## Farmers Sand Application M2024057- Preliminary Adequacy Review Letter

Attached to this email is the Division's Preliminary Adequacy Review Letter for the proposed Farmers Sand 112c reclamation permit application, DRMS File No. M-2024-057.

**Re: Farmers Sand, File No. M-2024-057**  
**Receipt of 112c Construction Materials**  
**Preliminary Adequacy Review**

Exhibit A- Mule Deer Severe Winter Range indicated in striped pink.

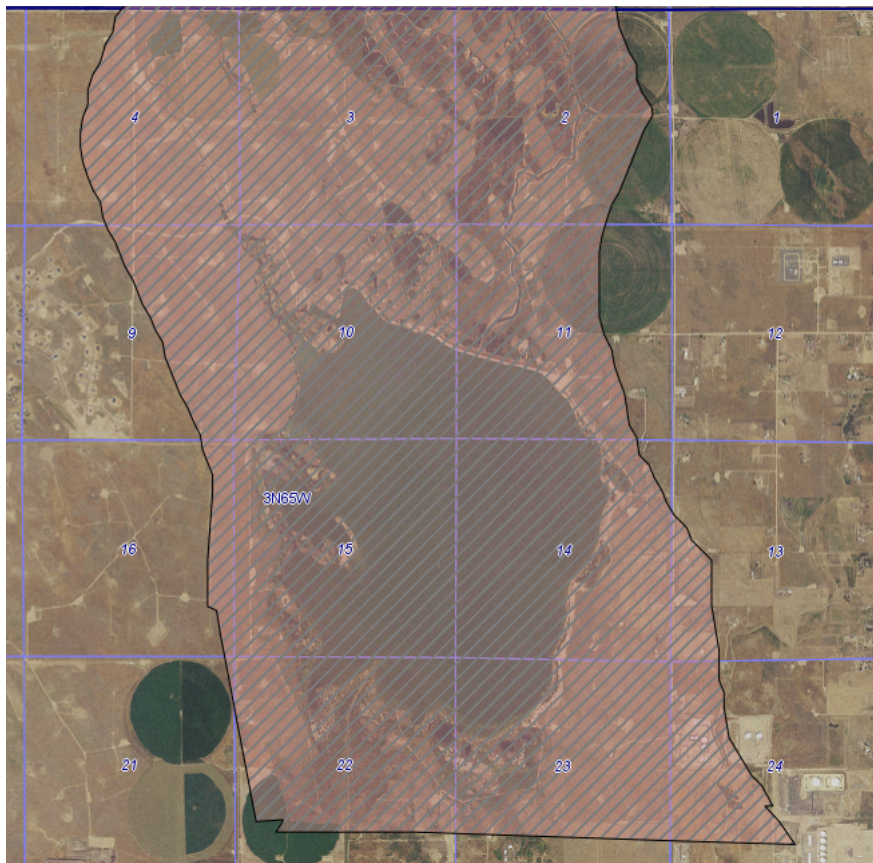
Mule Deer Severe Winter Ranges are defined as that part of the overall winter range where 90% of the individuals are located when the annual snowpack is at its maximum and/or temperatures are at a minimum in the two worst winters out of ten. These areas provide crucial wintering habitat during both severe and mild winters by providing ideal forage, vegetation, and topographic features for both species. Regardless of weather patterns, winter is the most stressful period for ungulates due to the challenges winter poses for forage availability. The entirety of the project is slated for development within these HPH layers (see Exhibit A below). Therefore, CPW recommends not constructing during the winter season (December 1 to April 30), if this is not feasible, CPW recommends that the applicant start construction outside of this window.

In particular, there is a bald eagle roost site around the entirety of Prewitt Reservoir as shown in Exhibit A.

Exhibit B- Bald Eagle Roost Site indicated in striped orange.

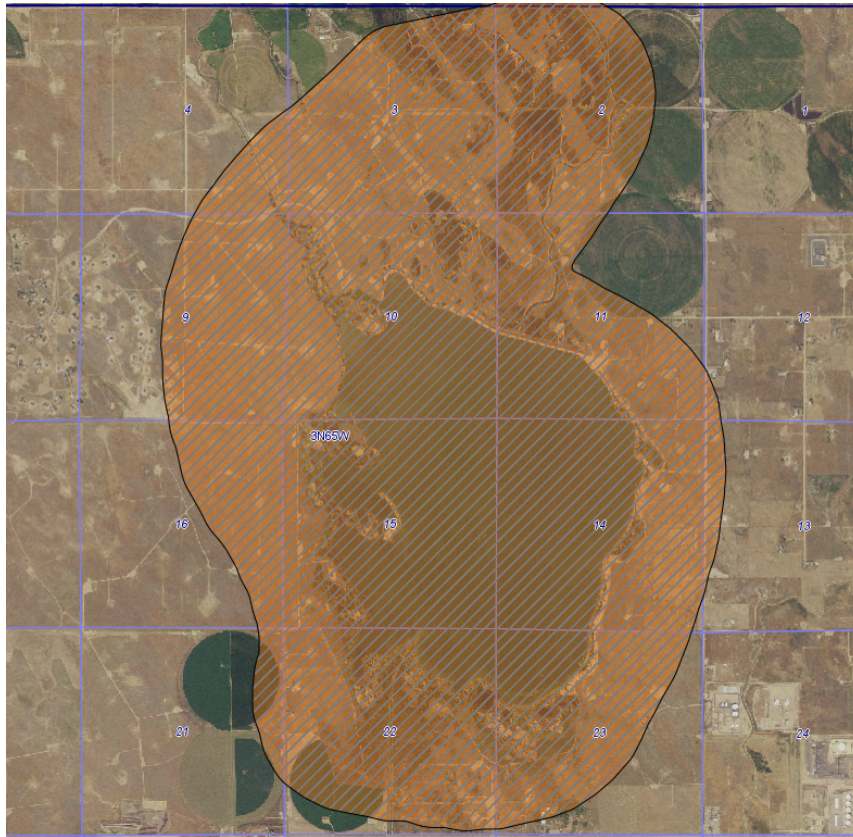
Bald eagle roost sites are defined as groups of (or individual) trees that provide diurnal and/or nocturnal perches for wintering bald eagles. These trees are usually the tallest available in the wintering area and are primarily located in riparian habitats. CPW has two recommendations to protect these sites: of a) no surface occupancy within 0.25 mile of any active bald eagle winter night roost year-round, and b) no human encroachment or disturbance within 0.5 mile any active bald eagle winter roost site from November 15 to March 15 of each year. We appreciate the applicant planning work from March - November.

In particular, there is a bald eagle roost site around the entirety of Prewitt Reservoir as shown in Exhibit B.

**Enclosure:** Maps showing contested land

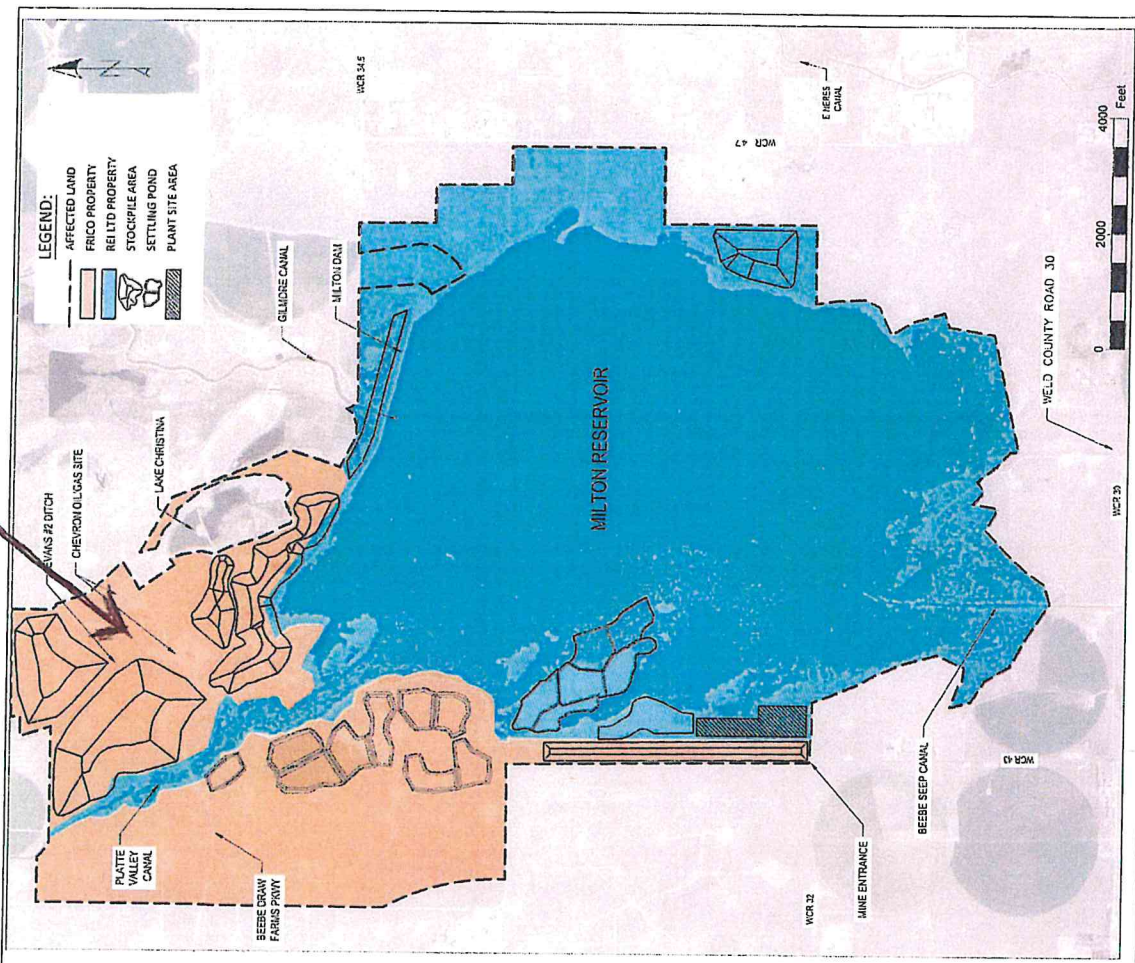
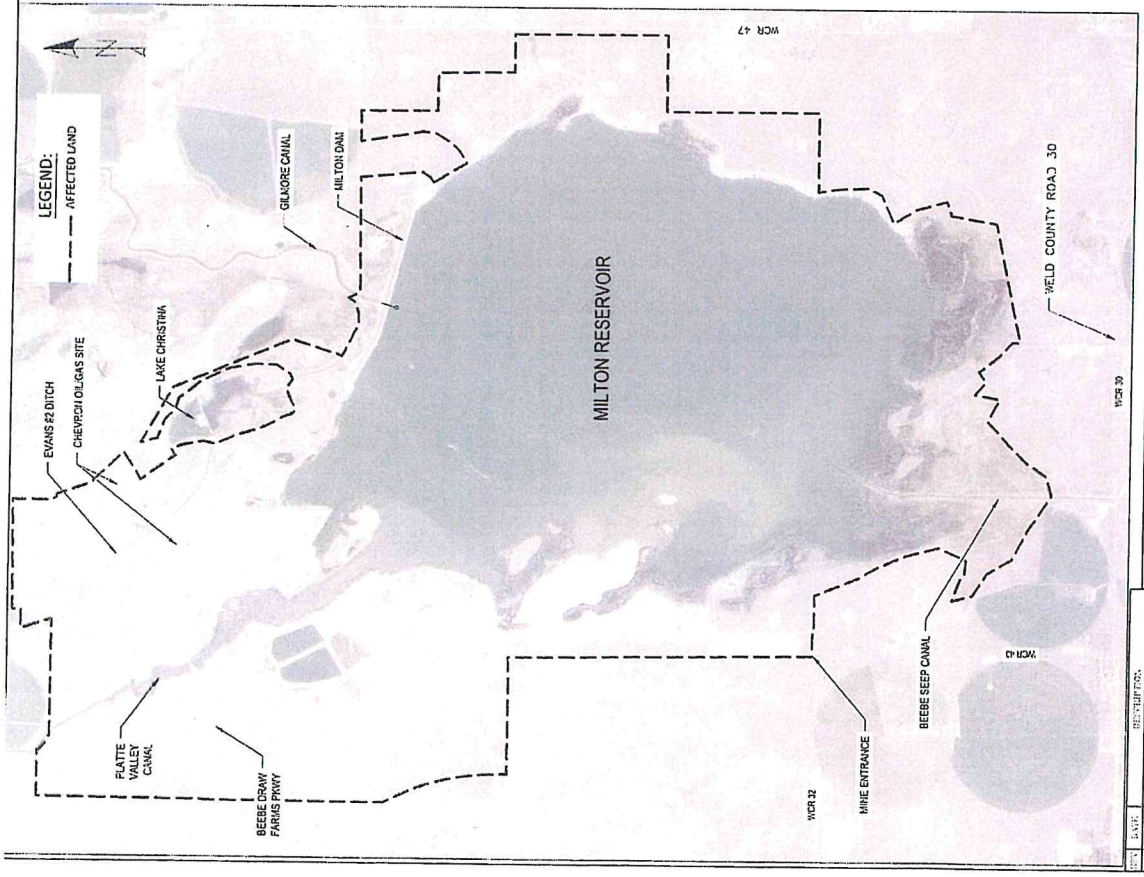
A portion of the land being used in the project is contested. Prior to April 2022, the taxpayers and residents of Beebe Draw Farms (BBDF), also known as Pelican Lake Ranch, owned 422 acres of land adjacent to Milton Reservoir through their governing Metro District entity. This land was primarily used as amenity space for recreation and conservation, with some improvements made to enhance its use.

In April 2022, without proper written authorization or notice as required by our governing documents, the developer, Christine Hethcock, who sat on the board of the Metro District, transferred ownership of 422 acres via quit claim deed to her private for-profit company, REI, LLC, for the sum of \$10. At the time, Ms. Hethcock served as the general manager and controlling interest holder of REI. Subsequently, in July 2022, just three months later, she sold her majority controlling interest in REI to a subsidiary wholly owned by FRICO.

FRICO, now the controlling interest holder of REI—and thus the land—entered into a \$0 perpetually renewable lease with REI for use of the land in its dredging project. Since this transfer, REI and FRICO have further profited from the land through oil and gas leases, as well as other subleases. All at the expense of the rightful owners of the land—the taxpayers and residents.

While I do not oppose the mining permit and recognize its potential to improve the area by removing the obtrusive sand piles, I must emphasize that FRICO continues to profit from unjust enrichment at the expense of the rightful owners of this land. It is crucial that this issue be addressed. I respectfully request that the land ownership dispute be resolved and that the rightful owners be compensated for their loss before this project proceeds any further.
